# **City of Bloomington Common Council**

## **Legislative Packet Addendum**

**Bloomington Common Council Ordinance No. 2026-06 to Amend the City of Bloomington Zoning Maps by Rezoning a 6.3 Acre Property from Residential Urban Lot (R4) and Residential Multifamily (RM) within the Transform Redevelopment Overlay (TRO) to Planned Unit Development (PUD) and to Approve a District Ordinance and Preliminary Plan**

Attached is the staff report which pertains to Plan Commission case Z02025-12-0018. The Plan Commission heard this petition at the February 9, 2026 hearing and voted 8-0 to send this petition to the Common Council with a favorable recommendation.

JACKSON STREET

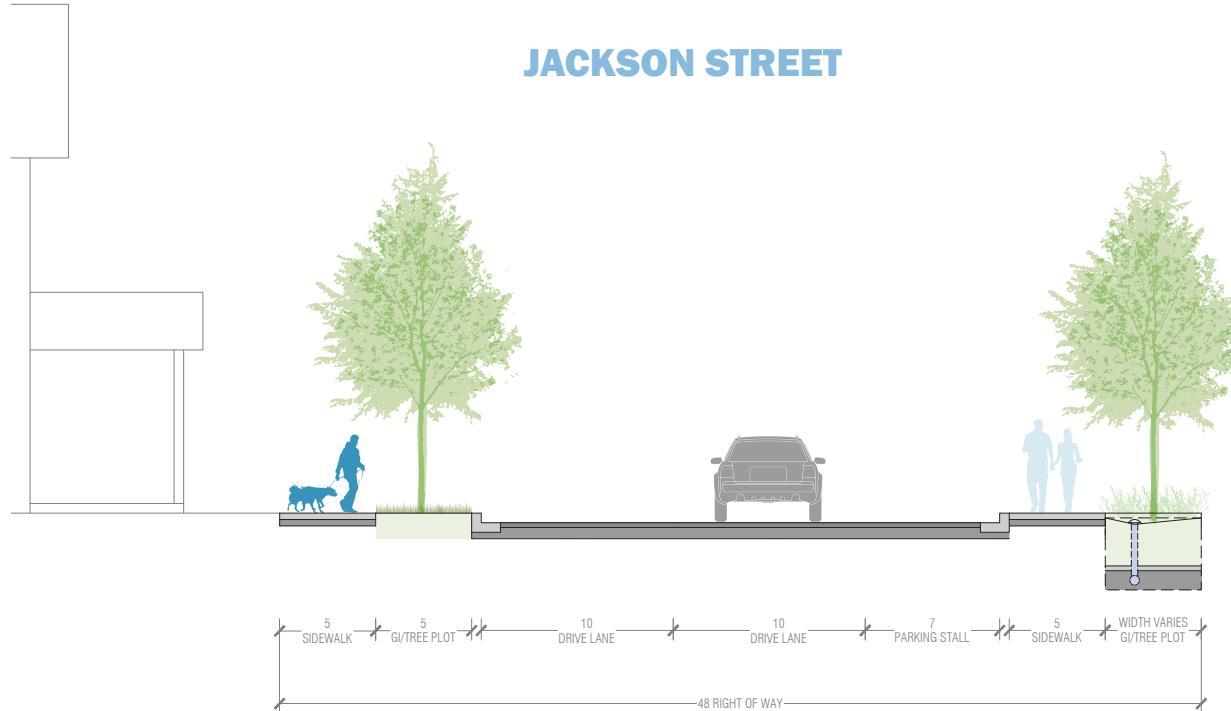
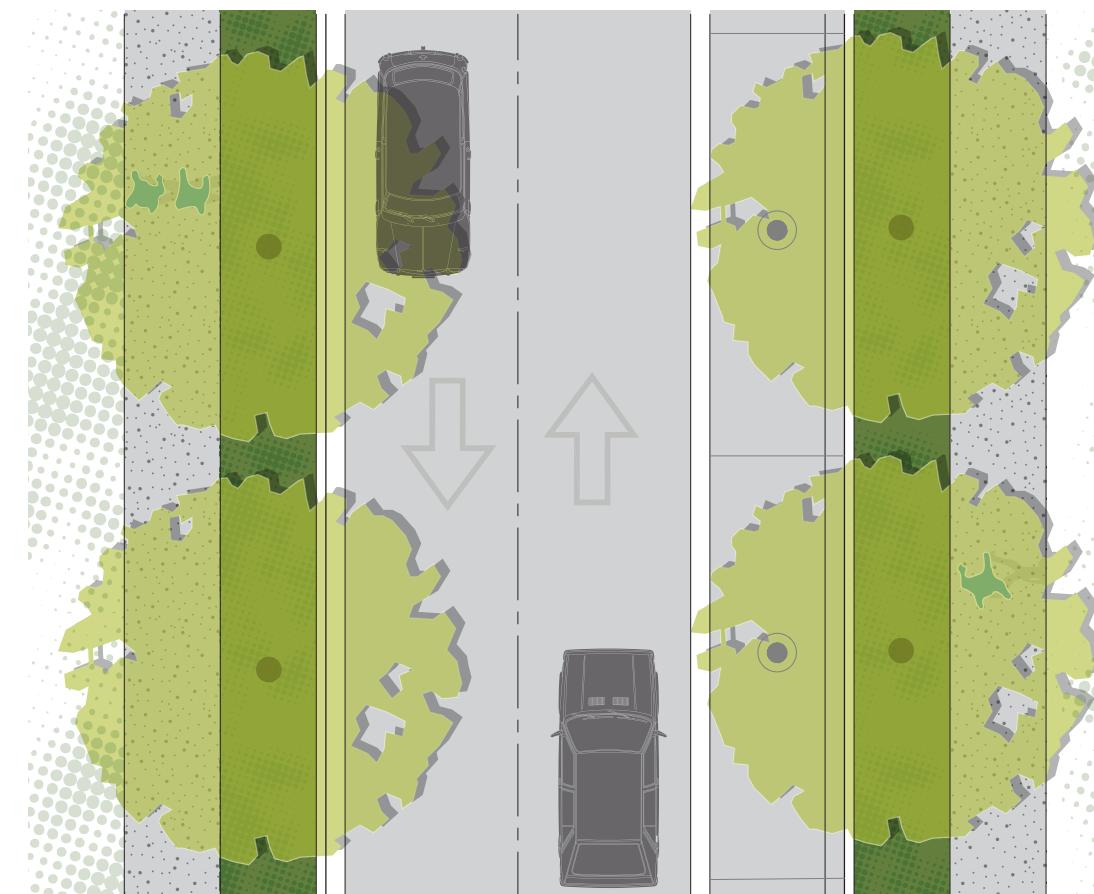
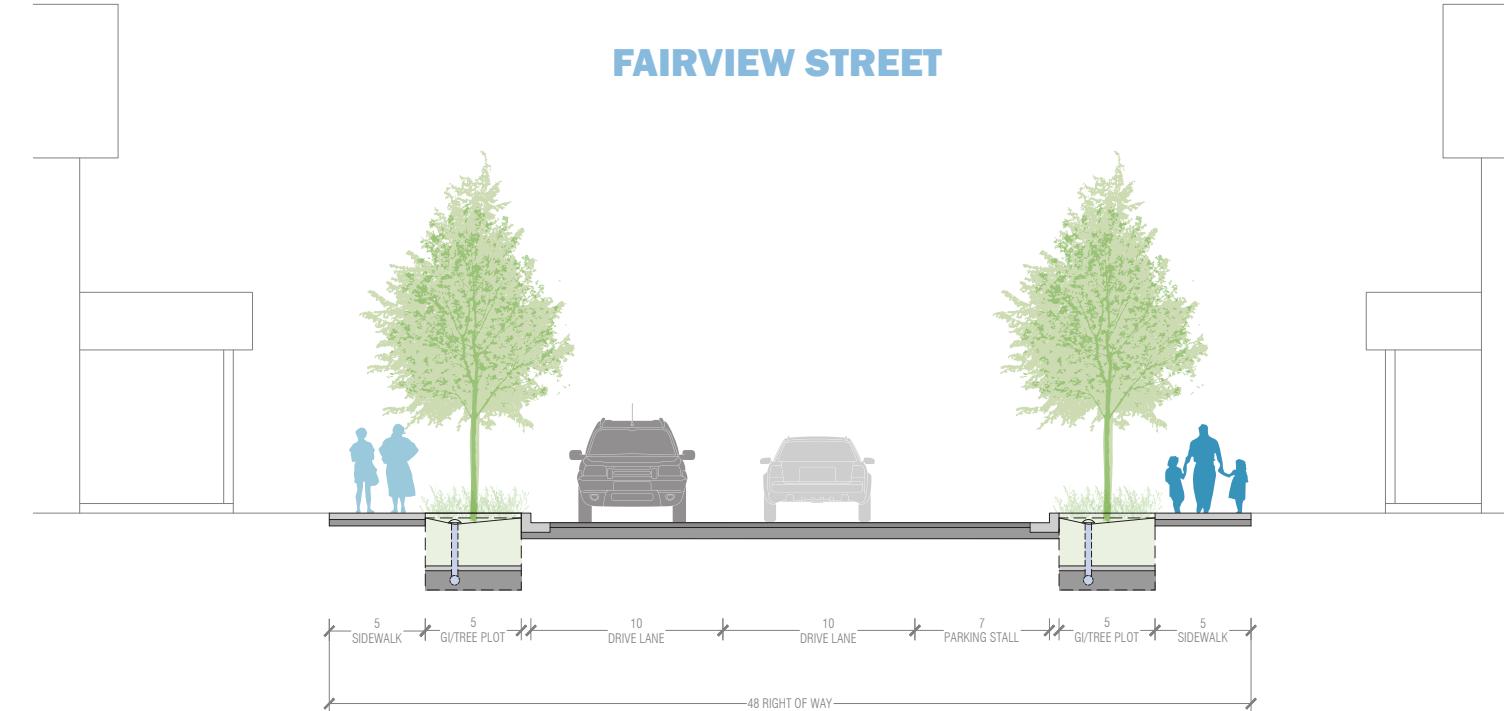
- Jackson Street
  - The Transportation Plan would require a total of 60' of right-of-way. With this petition Jackson Street would be constructed through this site to connect to 1<sup>st</sup> Street to the north and Wylie Street to the south. The City's recent improvements to 1<sup>st</sup> Street constructed an intersection along 1<sup>st</sup> Street for Jackson Street to connect to and it is in place. In order to maximize housing potential, while also balancing appropriate infrastructure needs, the petitioner is proposing a 48' right-of-way that would include 5' sidewalks and 5' tree plots on both sides, 2- 10' travel lanes, and a 7' wide on-street parking lane on the east side.

- Fairview Street
  - The Transportation Plan would require a total of 60' of right-of-way. Fairview Street currently extends through the site and would be removed and reconstructed with this proposal. In order to maximize housing potential, while also balancing appropriate infrastructure needs, the petitioner is proposing a 48' right-of-way that would include 5' sidewalks and 5' tree plots on both sides, 2- 10' travel lanes, and a 7' on-street parking lane on the east side.

WYLIE STREET

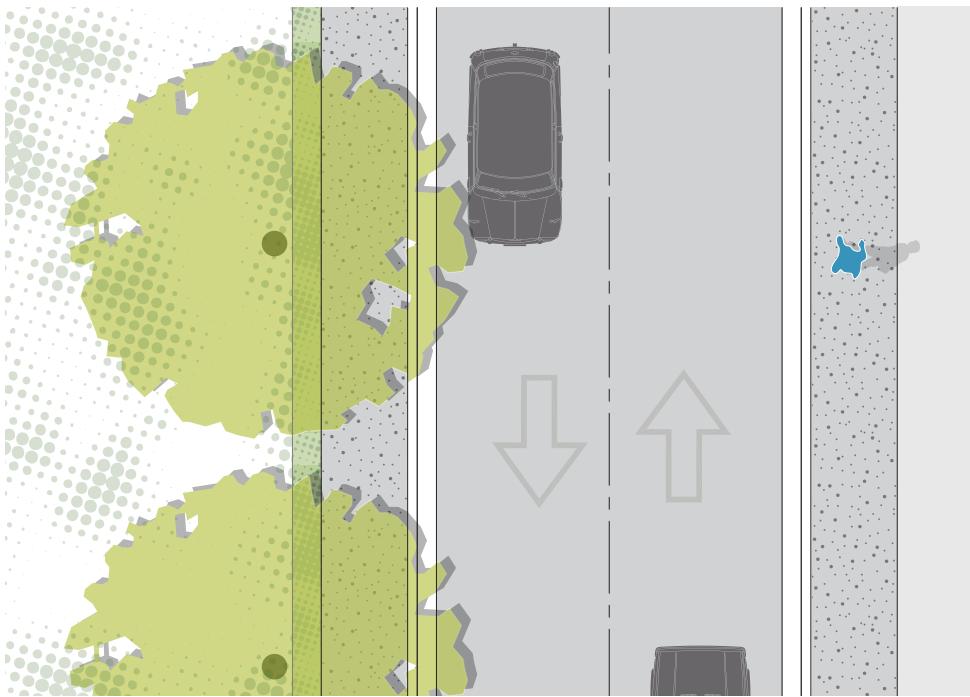
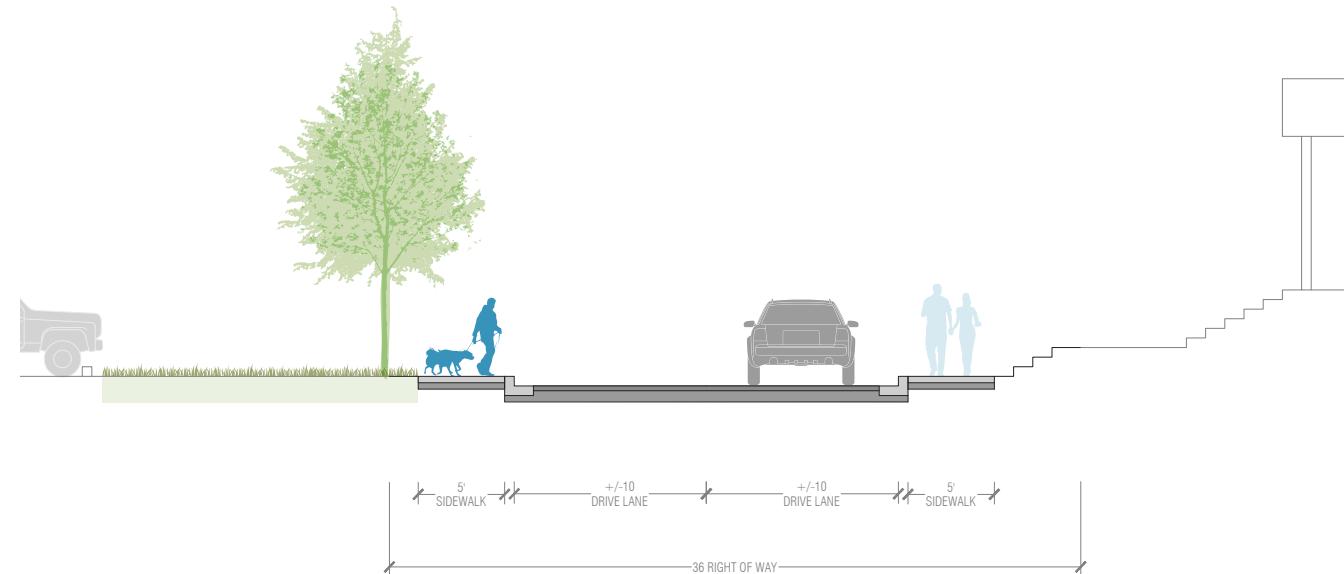
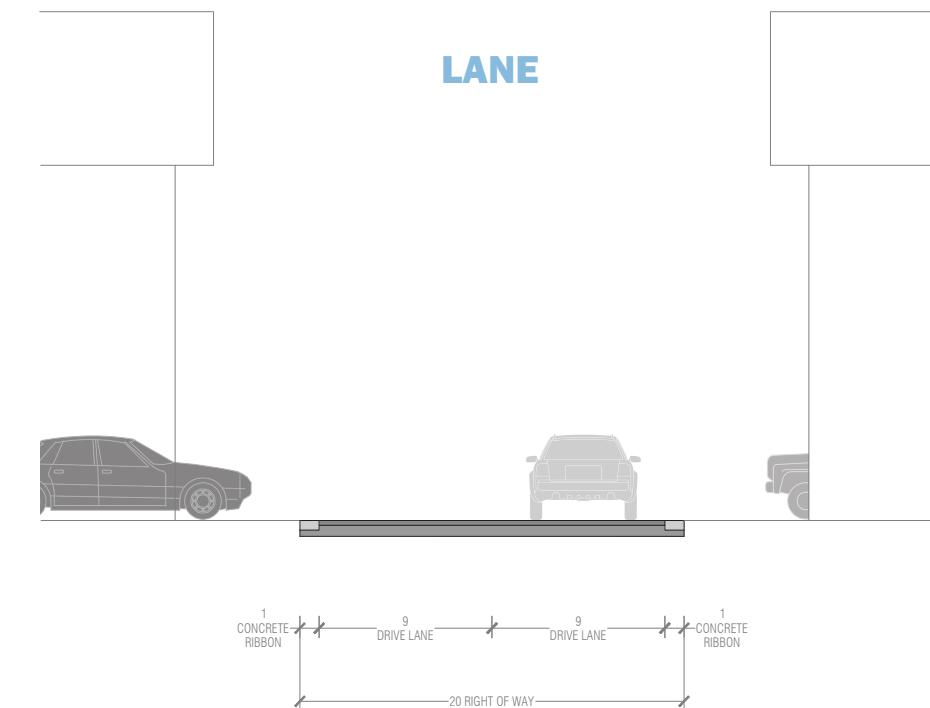
The petition involves the construction of several new roads within the development that have cross sections and proposed right-of-way widths that differ substantially from what is shown within the Transportation Plan. This particular element was one of the main reasons that a PUD was necessary. All internal streets will be public, but will have specific cross sections that differ from what is allowed in the Transportation Plan. Access to the site will come from existing public streets that border this site (Rogers Street to the east, 1<sup>st</sup> Street to the north, and Wylie Street to the south), an existing section of Fairview Street that bisects through the site, an extension of Jackson Street through the east side of the site, and new streets identified as 'Lane' that will provide access to the interior of the development. The proposed 'Lanes' would function similar to a conventional alley, and would have 20' of right-of-way with two, 9' travel lanes and

- Wylie Street
  - The Transportation Plan would require a total of 60' of right-of-way. But, of residential streets, the Plan also states "in order to preserve existing neighborhood fabric, existing streets shall not be required to conform to these cross-section standards". There is currently approximately 40' of right-of-way. The proposed cross section shows maintaining the existing right-of-way line with no additional dedication. There is currently an approximately 4.5' monolithic sidewalk along the north side of Wylie Street along this frontage that would be replaced with this petition with a monolithic 5' sidewalk. There is also on-street parking along the north side of Wylie Street along this property frontage which is proposed to remain. The proposed cross section shows maintaining the current monolithic sidewalk.
